PROJECT :  
VALOUR COMMUNITY CENTRE  
GYMNASIUM ADDITION  
AND RENOVATIONS

TITLE:  
INTERIOR DOOR  
ELEVATIONS

**AR-1**

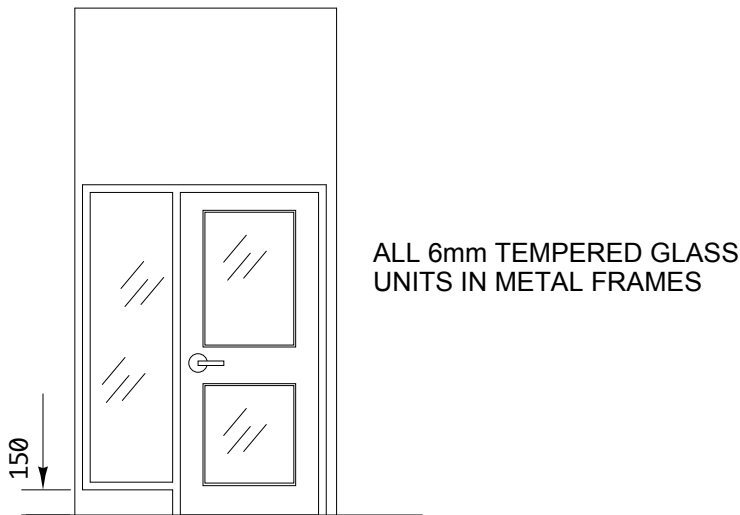
THIS INFORMATION SUPERCEDES THE DOOR SCHEDULE ISSUED AS PART OF THE ORIGINAL TENDER DOCUMENT PACKAGE.
